MARIN COUNTY COMMUNITY DEVELOPMENT AGENCY

DIPSEA RANCH LAND DIVISION PROJECT INITIAL STUDY / MITIGATED NEGATIVE DECLARATION AMENDMENT

COMMENTS ON THE IS/MND AMENDMENT AND RESPONSES TO COMMENTS

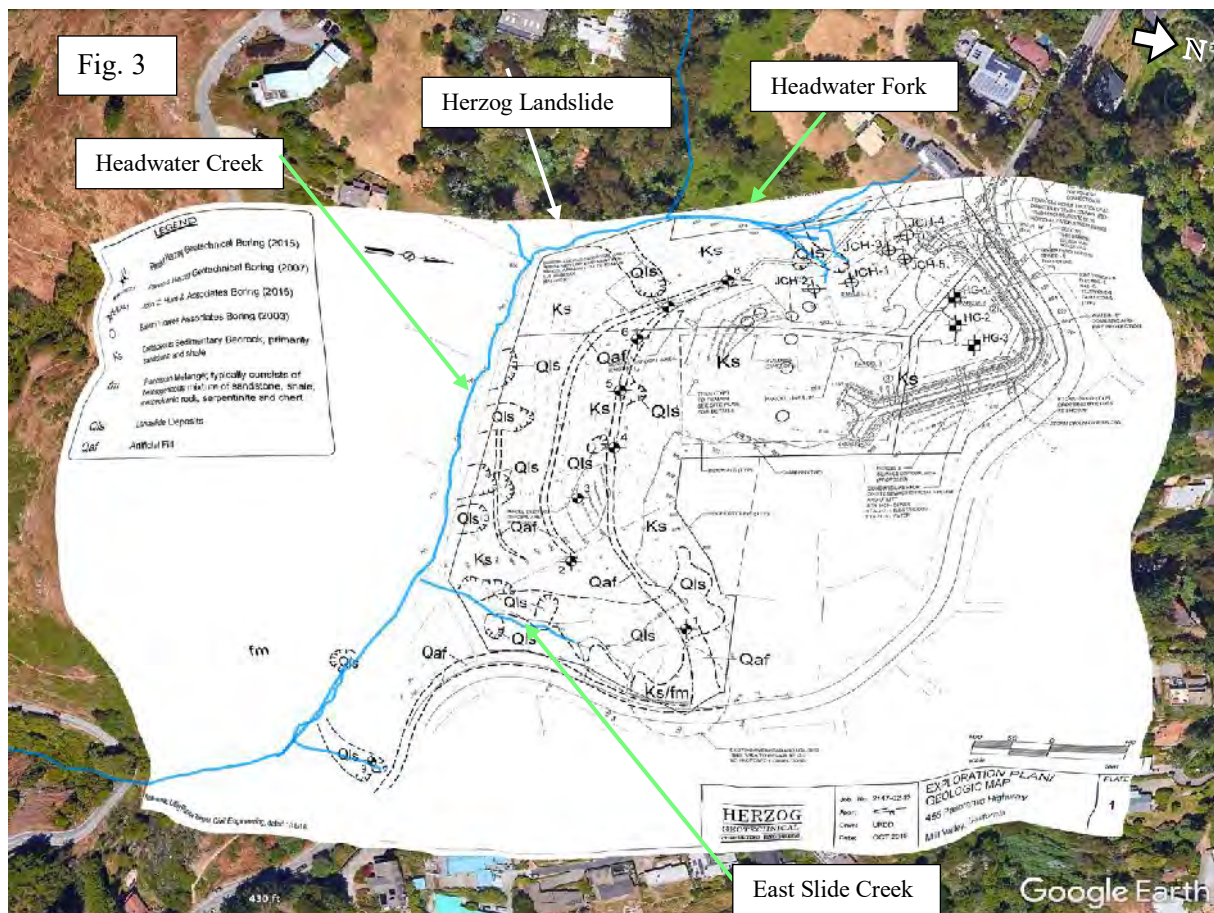
Figure 3 Shows the 2018 Herzog Exploration Plan/Geologic Map herein referred to as the Herzog Landslide Map (HLM) (note that even though the map legend on the image below says 2015 the map is also in the 2018 updated report with no apparent changes). It is not clear how the initial interpretation of landslides was conducted other than HGR referencing in their report that they performed a geologic reconnaissance of the site and reviewed selected geologic references. The HLM overlay looks wavy in Figure 3 because it is a 2-dimensional map fitted to topographic projection of Google Earth. The stream mapping by L. Collins has been left on to show the relationship of the key stream channels to the HLM, which are not delineated by Herzog. As can be seen, a multitude of information is provided on HLM but essential information concerning the on-site and off-site and stream network is entirely missing. The added blue line (from L. Collins mapping) is left on other Google Earth images in this report to show approximate channel locations and context. To address the #2) current condition of slope stability around the Fire Trail; and #3) the location of drainages on the property in relation to stream and conservation areas, any methods employed to divert water from these areas, and associated impacts from the drainages and diversion of water from those areas, this analysis copies and highlights key features of the HLM that are necessary for this review, including landslides (Qls), road fill (Qaf), existing and proposed sewage disposal areas, culverts, and lots.

Although the Older Fire Trail fills (light orange linear polygons identified as the Qaf geologic unit) are delineated in the HLM, Herzog consultants did not map the extent of unstable road cuts in the Project area even though they discussed them in the HGR. The thick green arrow in [Figure 5](#) points to the area of the road cut of the Older Fire Trail that is discussed as unstable in both the original and updated Herzog Geotechnical reports, but it is not delineated in the HLM.

In her description of Figure 3, the commenter states that,

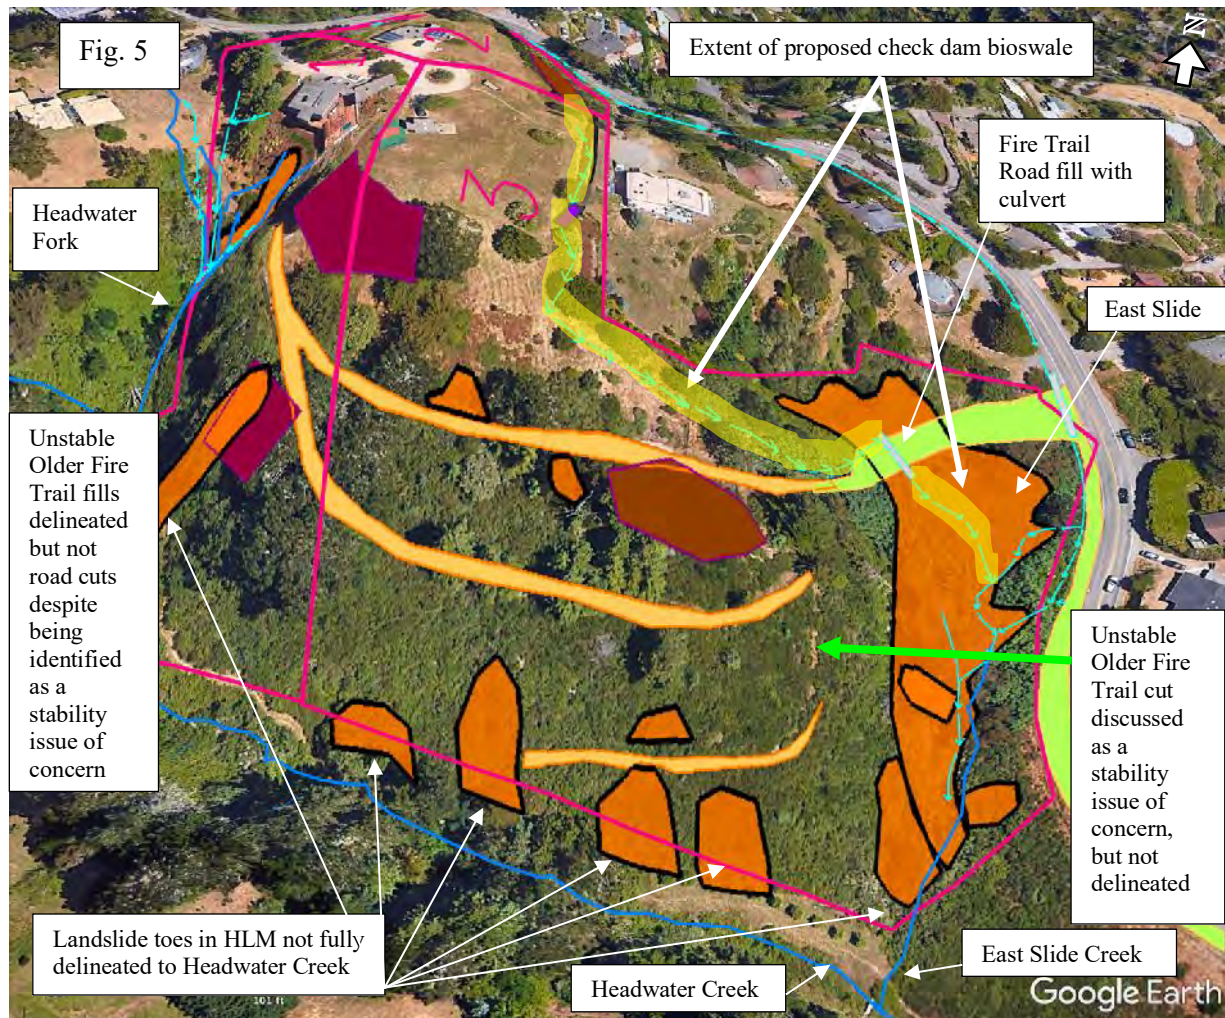
Figure 4 shows the key features of the HLM highlighted in different colors. The landslides (Qls) are shown as orange polygons with black outlines. One landslide, the largest delineated in the Project area by the HLM, is referred here as East Slide. It is located within the east side of Lot 3 and shown with a bright yellow arrow.

The lot boundaries are traced as pink lines with the appropriate lot numbers also shown in pink. Older road fills (Qaf) are shown as light orange (within black dashed lines of map) and newer road fills are shown in light green (within dashed lines). The newer, yet nonengineered 2014 fill is referred to as Fire Trail Road fill. It crosses the East Slide and is shown with a thick black arrow. It ends at the intersection of the Fire Trail driveway with Panoramic Highway. Even though the HLM shows fill extending along the Highway, it is not discussed further in

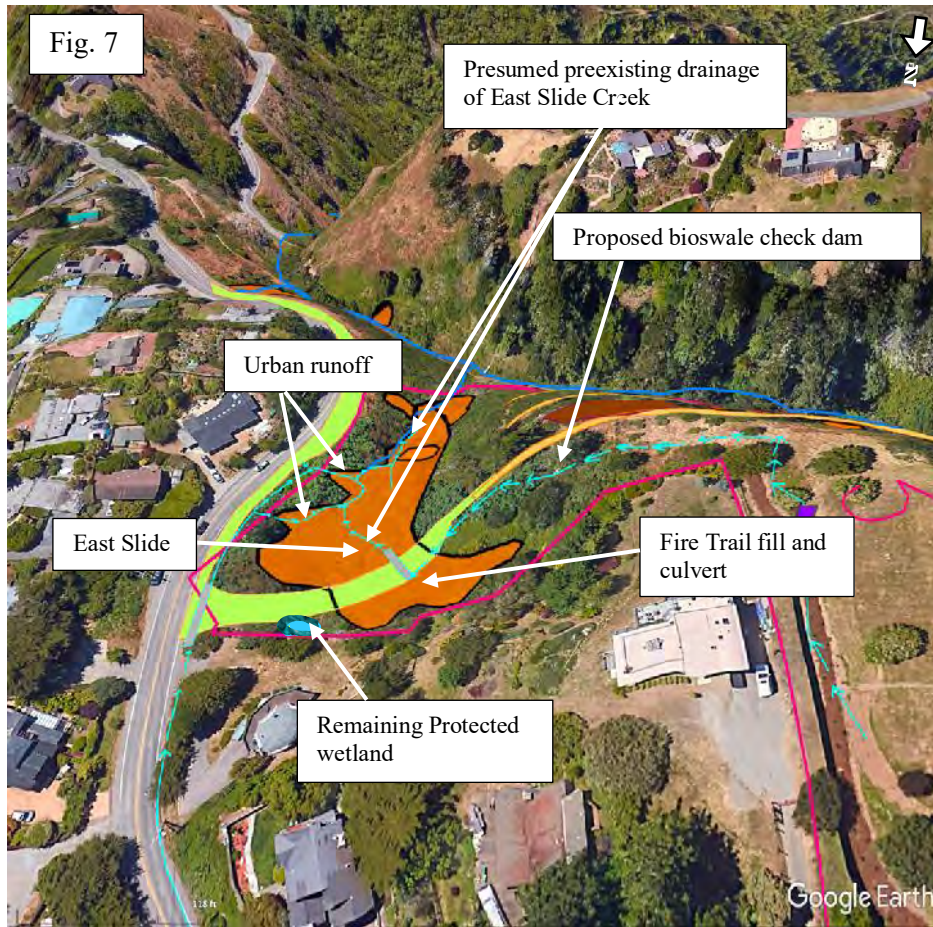
Figure 8 from 2020 Lotic Environmental shows a photograph that diagrammed the potential prior extent of the protected wetland prior to the placement of the 2014 Fire Trail fill. The fill was added for the presumed improvement of the 2014 Fire Trail even though it has never been approved or accepted for that use because it was never engineered to any standard. The Fire Chief also stated that the road was not engineered for fire trucks, further providing doubt to the Developer's claims. AR 65. After notice of illegal filling in a Stream Conservation Area

In [Figure 8](#) a former wetland tributary is shown to be flowing (yellow arrows) from the wetland into the area that is now buried with 1200 cubic yards of fill for a road that technically cannot be used for fire protection due to its lack of engineering standards. Here a blue arrow has been inserted to indicate a possible preexisting channel that required drainage at the fill that does not lead to the wetland. On the other hand, it could also lead into what appears to be the lateral scarp of the East Slide delineated on the HLM and here sketched as a white line. This landslide is presently the base of support for the Fire Trail fill. No known efforts were undertaken to stabilize the East Slide by dewatering it or redirect water draining into that contributes to its saturation and instability.

The commenter’s interpretation of the features in Figure 8 are, yet again, based on speculation. The area of green vegetation represents a topographic low where drainage from the slope and Fire Road to the east (toward Panoramic Highway) collects and ponds. This area was covered when the Fire Road fill was placed but this is also the location that the culvert was installed to facilitate drainage and avoid surface water impoundment behind the newly placed (2014) Fire Road fill. The statement that the preexisting channel (marked by the blue arrow) “could also lead” to the lateral scarp of the East Slide is unfounded and is not based on field observation. Contrary to the commenter’s claim, the culvert was installed beneath the 2014 Fire Road fill in an area that received local surface water drainage in order to dewater and redirect flow and avoid surface water contributing to erosion of the Fire Road fill.

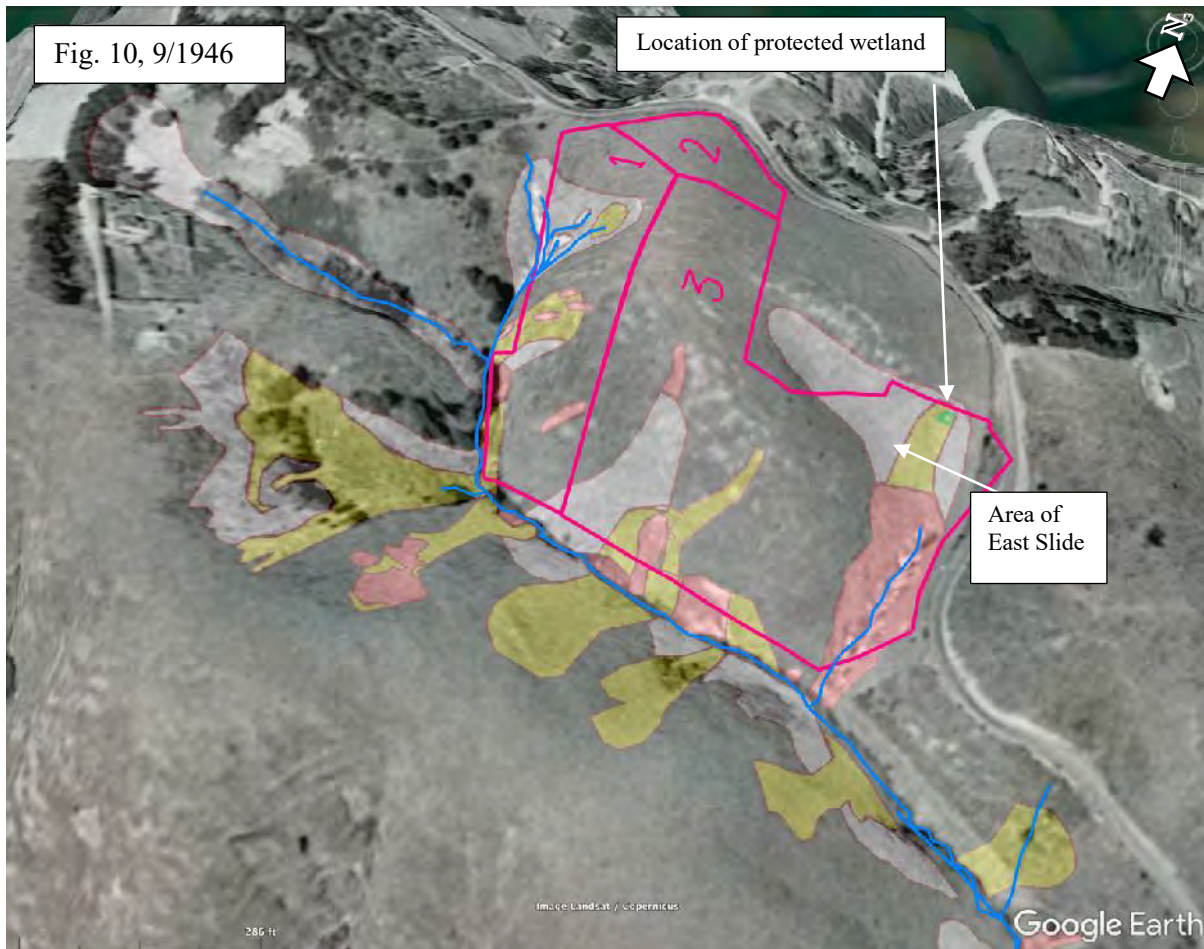
Figure 10 shows the same 9/6/1946 Aerial Photo GS-CP 5-2 overlaid onto Google Earth Imagery, but it also shows the same channel mapping of the stream network by L. Collins depicted in Figures 2 and 3, and the Project Lot lines (pink lines). It also delineates interpreted landslides from the 1946 imagery. Landslides mapped as red polygons were likely active < 50 years prior to 1946, perhaps by the turn of the 1900s (76 years before present), while landslides mapped as yellow polygons were likely active sometime during the 1800s (between 76 and 222 years before present). Landslides mapped as white polygons likely predate European settlement and could include very old landslides that predate impacts of European settlement to ancient slides that were last active during or shortly after the end of the Pleistocene Epoch (>222 years before present and less than 11,700). On Mount Tamalpais, these latter slides can commonly be colluvium filled hollows that can look like topographic swales of lack little topographic expression at the topographic depressions (zero-order basins) above heads of channels. The colluvium-filled hollows can fail catastrophically as debris slides during very intense and/or prolonged rainfall events (S. L., W. E. Dietrich, C. J. Wilson, and J. D. Rogers, Colluvial deposits and associated landslides in the northern San Francisco Bay area, California, USA, Proceedings of the 4th International Symposium on Landslides, pp. 425-430, 1984).

Some of the landslides mapped in Figure 9 appear to be colluvium filled hollows, while others appear to range from shallow debris slides, simple rotational slumps, to complex deep-seated earthflows that can have multiple failure planes (slip surfaces within the body of the slide). The nature of sliding at the East Slide area looks like it has had a history of shallow debris sliding and slumping near the head scarp of the white polygon and deeper-seated earthflow movement within the body of the white polygon. The yellow polygon, within the white-colored, older slide area, appears to have been active sometime between the 1800s and 1946. It is conservatively depicted as older than the recently active portion of the East Slide, as represented by the red polygon below the yellow one. As can be seen in Figure 9, gullying by East Creek is deeply incising the lower active portion of East Slide within the red polygon.

In my interpretation, East Slide is a large complex earthflow, exhibiting multiple modes of failure that have occurred over a broad time span. East Slide is active in some areas and as discussed in the HGR, it displays hummocky and lobate topography indicative of previous earthflow landsliding (AR 01822). The body of the East Slide mapped

- 4-19 In Figures 9 through 26b and associated discussion, Ms. Collins presents a lengthy evaluation of historic slope instability on the property and on adjoining parcels based on aerial photography from select years (1946, 1955, 1965, 1987, 1993, 2002, 2007, 2008 2013). However, as stated in the response to comment 4-14, the method used to identify and map landslide features is questionable. Aerial photographic interpretation is but one tool used by geologists to determine previous landsliding, but the process, when carried out correctly, requires high resolution, stereo-pair photographs viewed through a stereoscope, producing a 3-dimensional effect with an exaggerated vertical component. Ms. Collins did not use the stereo pairs approach but rather relied on importing single-frame digital images into Google Earth, resulting in a low-resolution, quasi-3-D effect. This approach provides some information, but it is grounds for questioning the validity of the commenter’s interpretations, and is not the best-available source of information.

Fig. 51

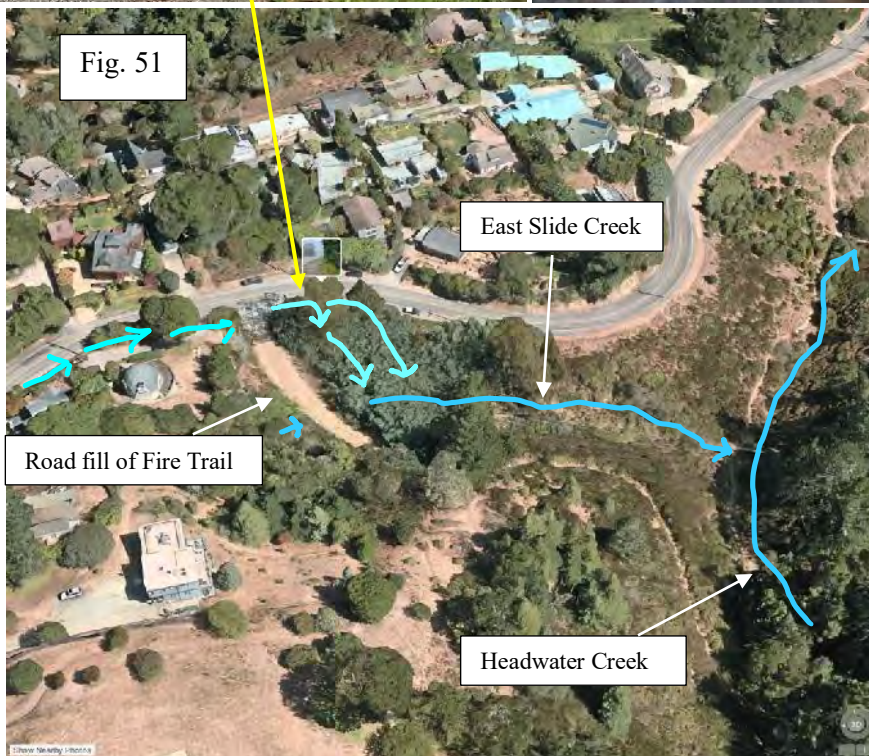
Figure 49 shows current conditions of the same location of Figure 50. The location site is shown by the yellow arrows in Figure 51. Figure 50 photo provided by Marin Watershed Alliance, was taken 5/2014. It looks downhill from the Fire Trail driveway at urban runoff flowing into a gully leading to East Slide Creek. Figure 49 shows the same cyclone fence (covered with ivy) in Figure 48. Figure 50 exemplifies the amount of water that can be produced by impervious surfaces. Flow from every impervious surface creates cumulative impacts of sediment supply from streambed and bank erosion of tributaries and to Redwood Creek's fish habitat and increased flood frequency.

Figure 6. Wetlands Road Encroachment

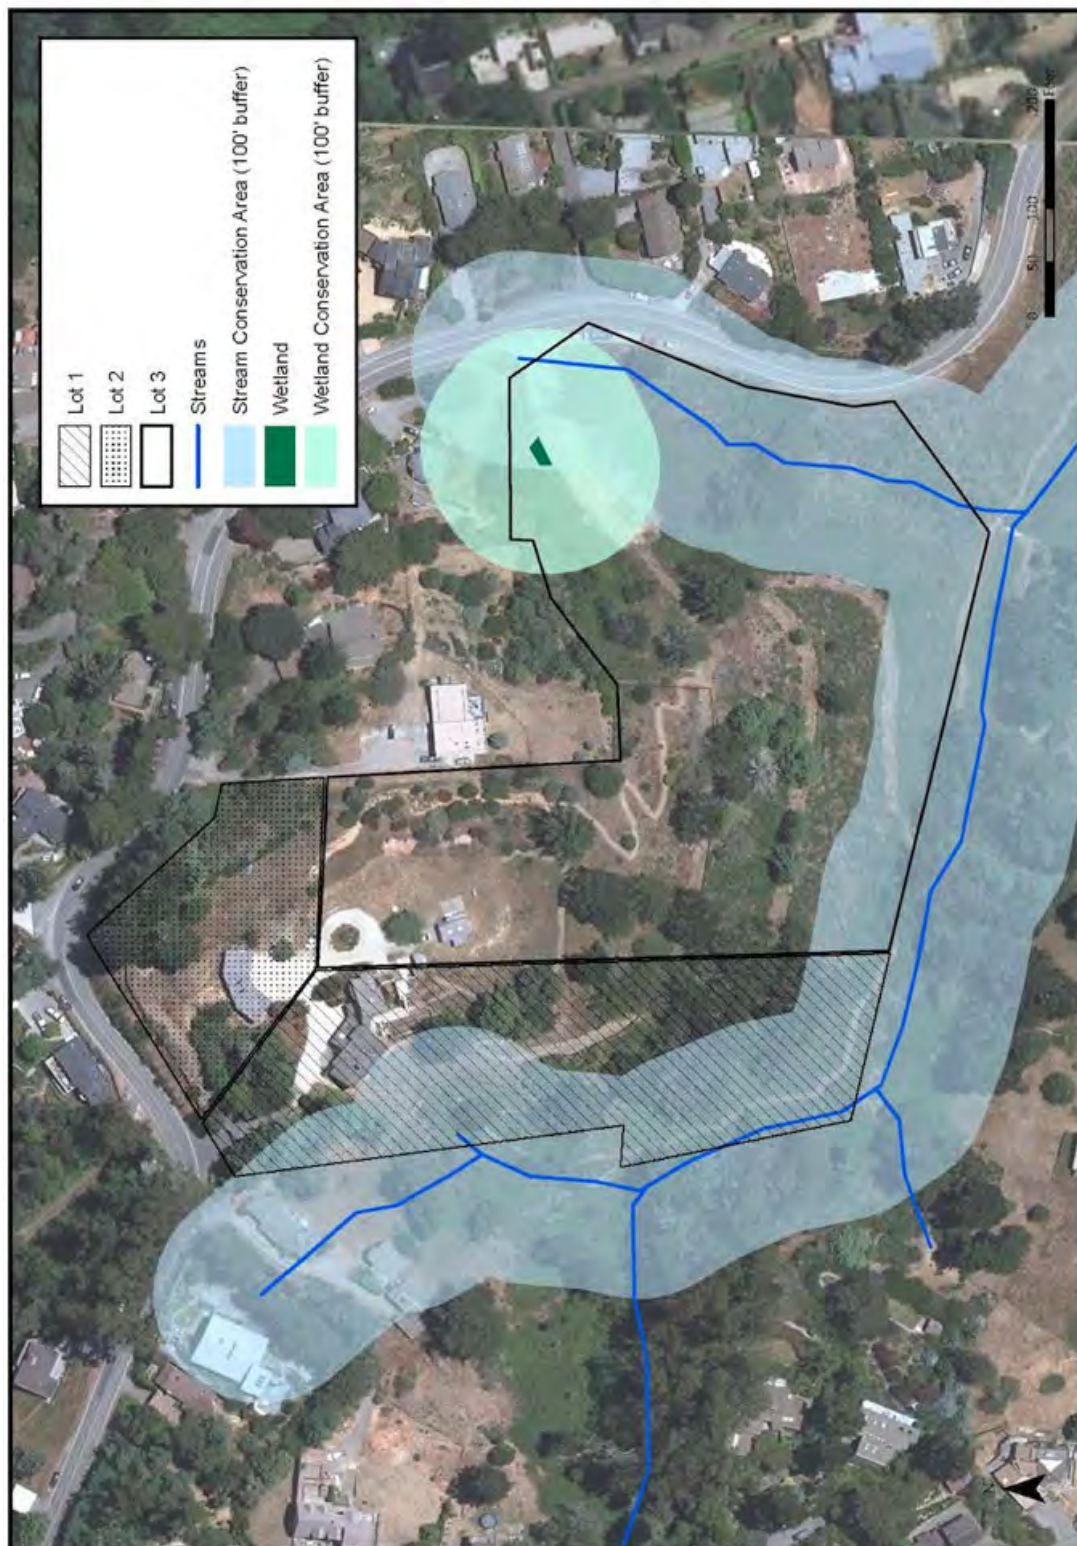
have the potential to buildup hydrostatic pressure and lead to separation of the fill from the native grade, potentially causing failure. Inadequate stormwater management on steep slopes and on new cut and fill will have an adverse impact on the habitat. Loss of groundwater infiltration with cisterns, pipes and bioswales impacts year-round base flows potentially dangerous for salmon downstream. (Figure 6 and 8)

Figure 7. Landslides

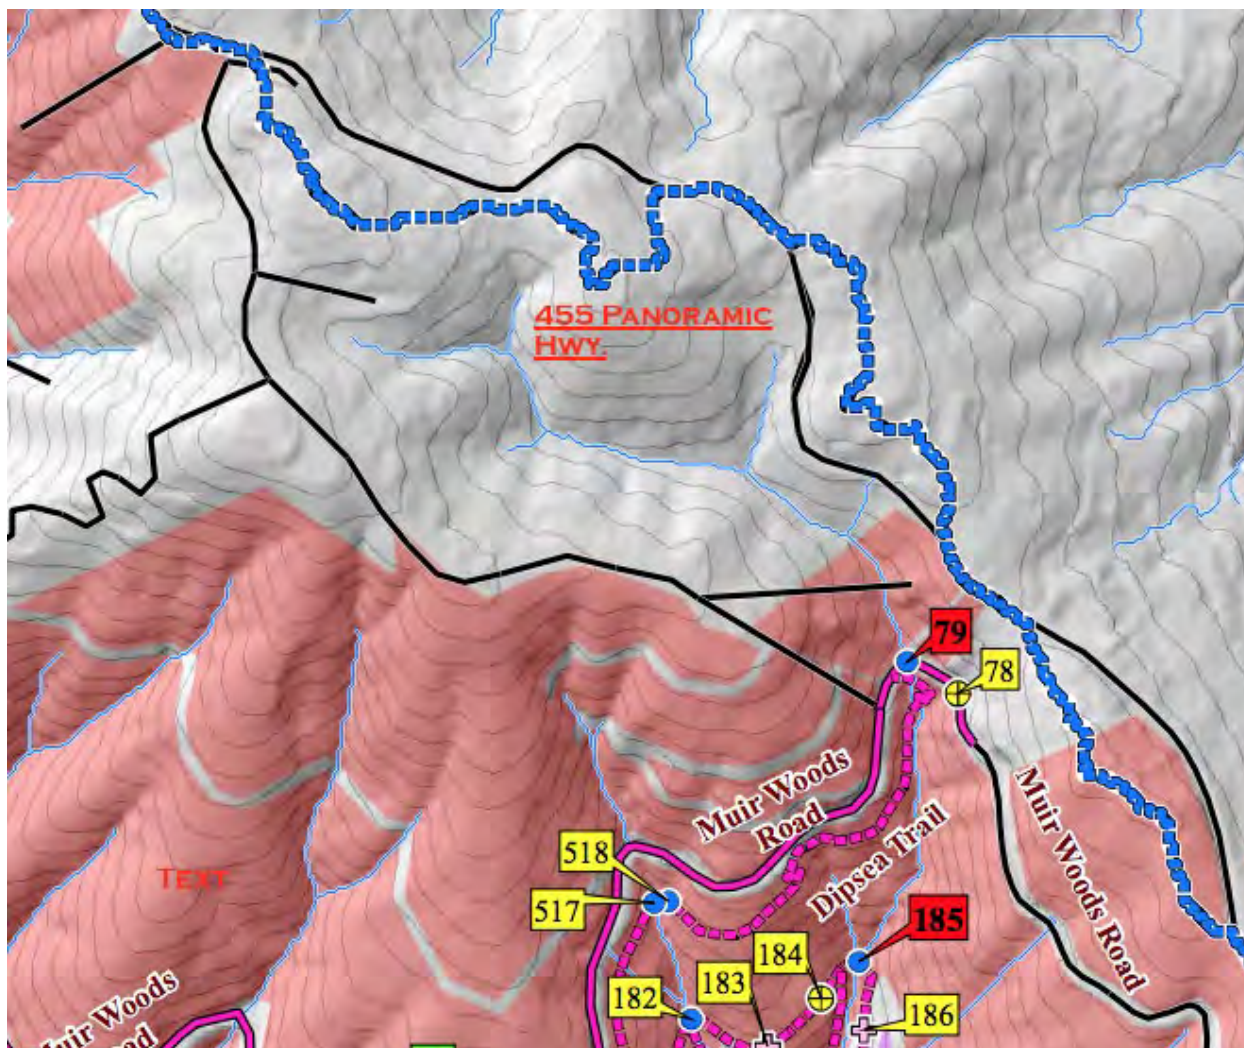
stormwater management plan proposal will likely cause a cascade of issues from increased velocity, increased landslides (Figure 7) increased suspended sediment, and increased erosion that will threaten salmonids. "The Project proposes the development of a stormwater management system that would utilize a system of storm drains, cisterns, and bio swales to control runoff." Ziegler Conceptual Stormwater Plan. This plan is inadequate for the high rainfall intensities and slope of the site.

Contrary to the AMND, hydromodification is very likely to occur given the land instability (Figure 7) and almost 40% slope, large grading of cut and fill, imperviousness of new housing and driveways, piping water off site in large concentrations with focused detention basins, bioswales and cisterns.
